DELHI INTERNATIONAL AIRPORT LIMITED
PHASE 3A WORKS
IGI AIRPORT, NEW DELHI

Comment Sheet

Sub Package 1:	PRW	Sub Package 2:	PRW
Sub Package 3:		Sub Package 4:	
Submission Title	SHOP DRAWING-MEGADOOR FOR ARFF-04		
Submission Reference	L&T/DIAL/DES/PTB/1089		
Response Revision No	A

Response Category		Remarks
A	No Comments	☐	
B	**Proceed subject to amendment as noted**	☑	**LEVEL B**
C	Resubmit subject to amendment as noted	☐	
D	Rejected	☐	
E	For information only	☐

DRAWING No. DIAL-LT-Q-UTL-A-10-101

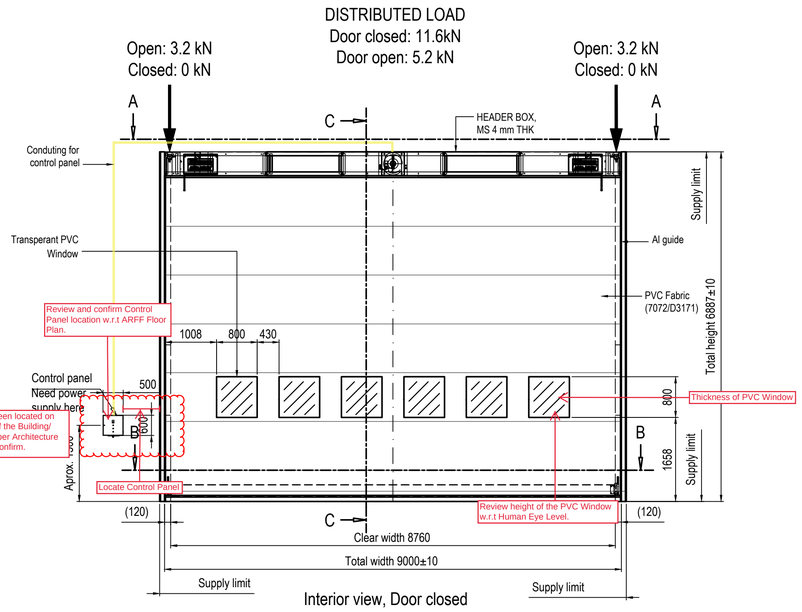
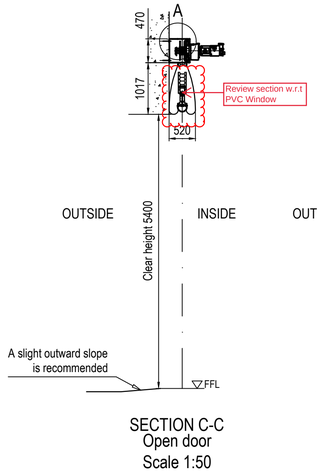
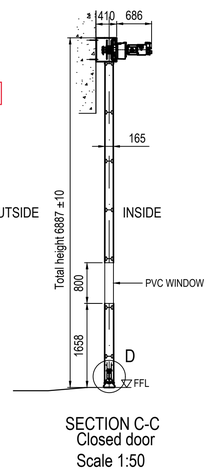
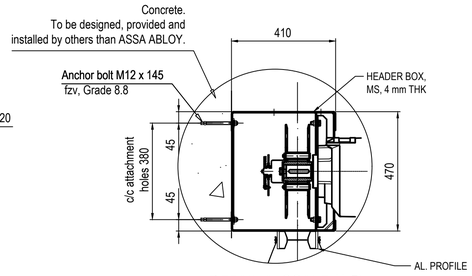
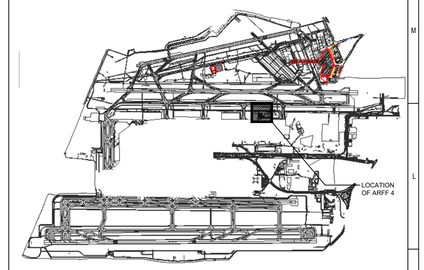
Include colour, thickness and finish of all components

Details of Hardware Set to be provided.

DRAWING No. DIAL-LT-Q-UTL-A-10-102

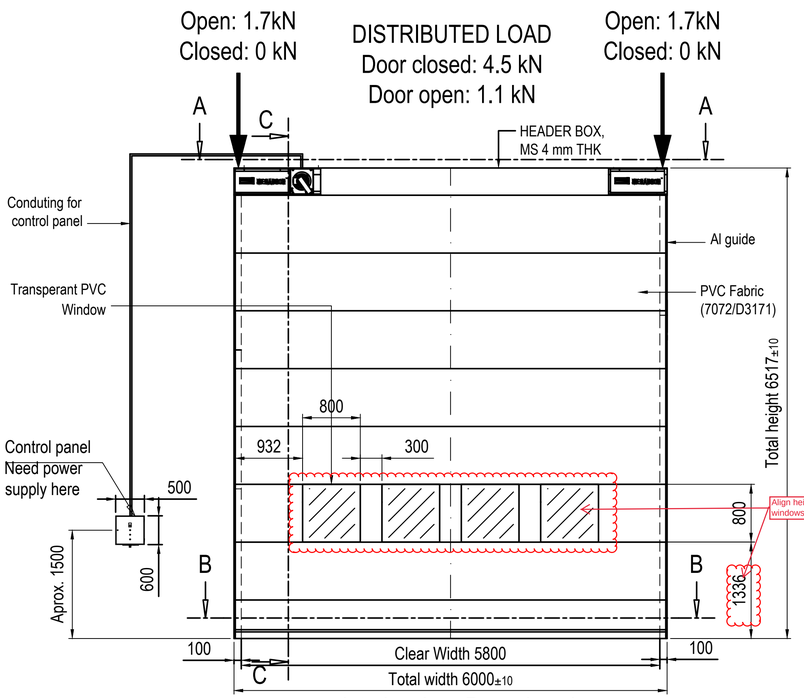
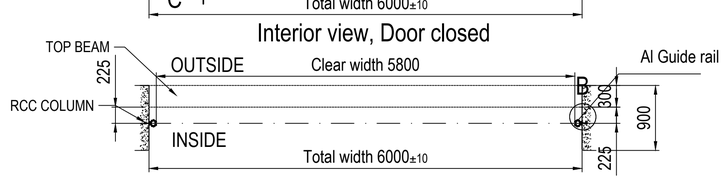
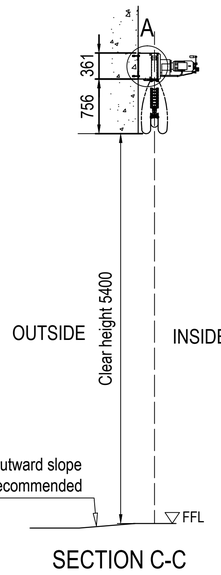
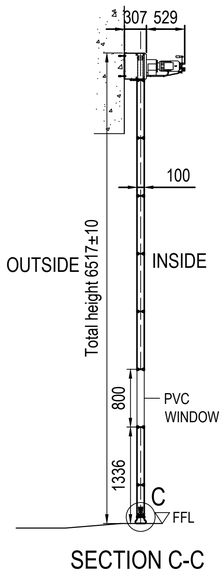
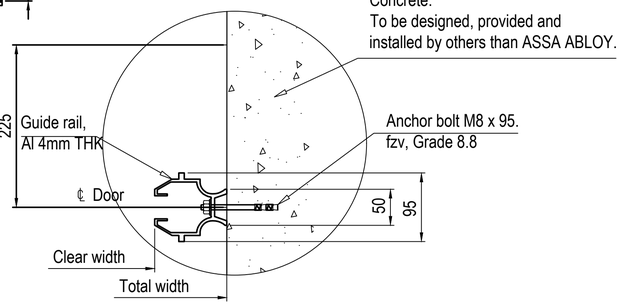
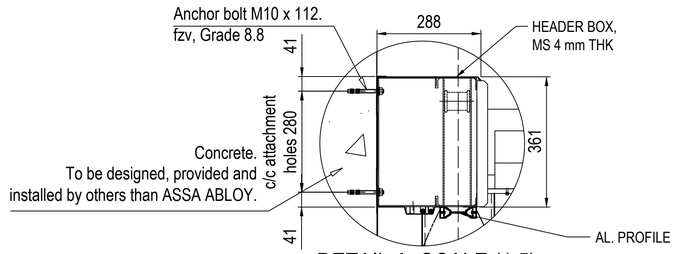
Refer comments on drawing
DIAL-LT-Q-UTL-A-10-101

DRAWING No. DIAL-LT-Q-UTL-A-10-103

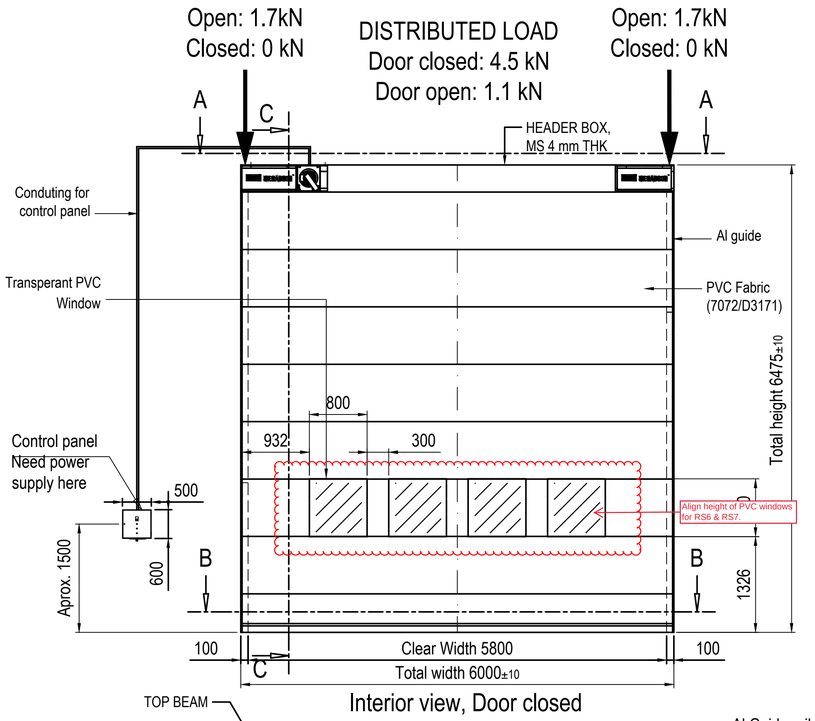
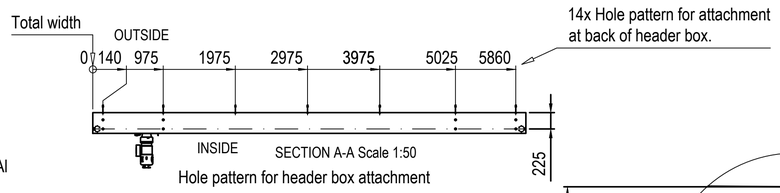
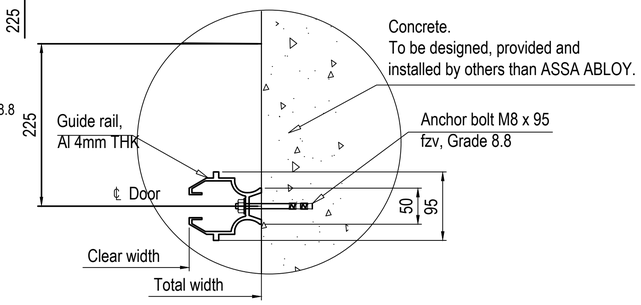
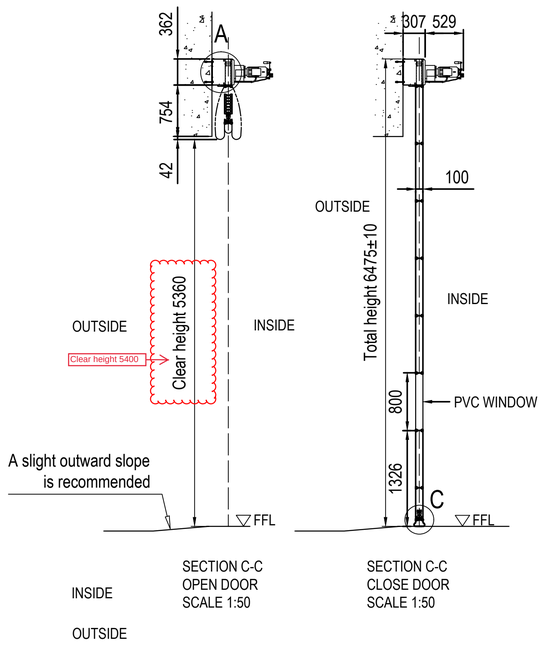
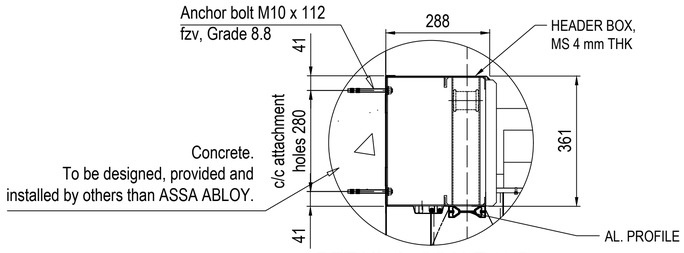
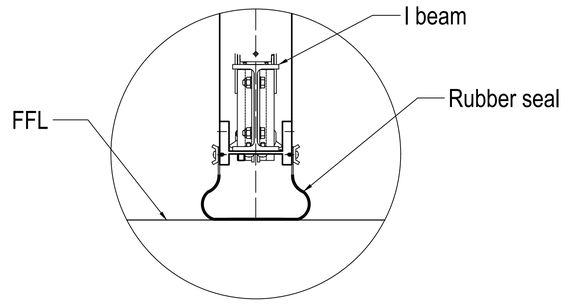
Refer comments on drawing DIAL-LT-Q-UTL-A-10-101

TITLE: ARFF5 MEGADOOR 8760 X 4988 (RS7)
SCALE 1:50
DRAWING No. DIAL-LT-Q-UTL-A-10-104
SHEET:
PROJECTION FIRST ANGLE
SIZE A1
REV A

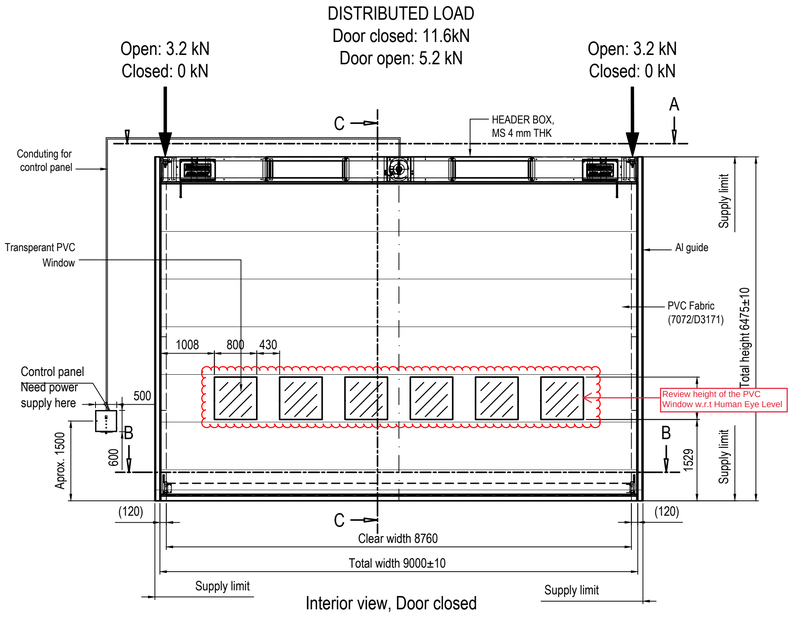
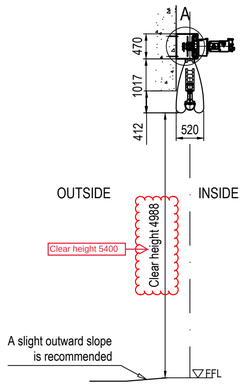
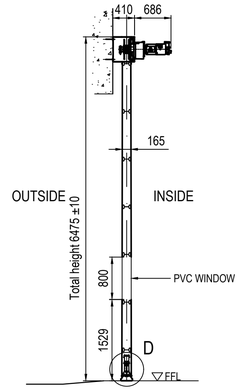
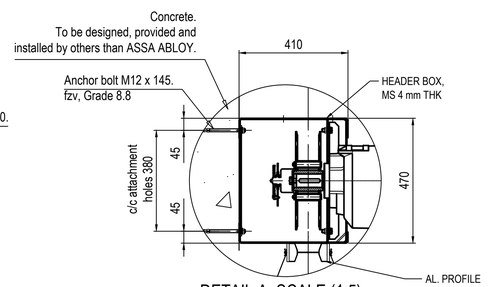
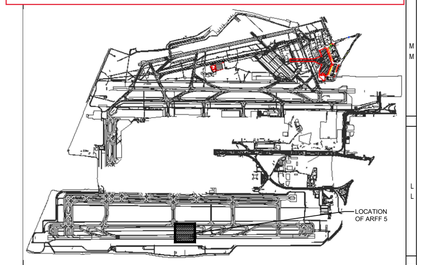
Refer comments on drawing DIAL-LT-Q-UTL-A-10-101
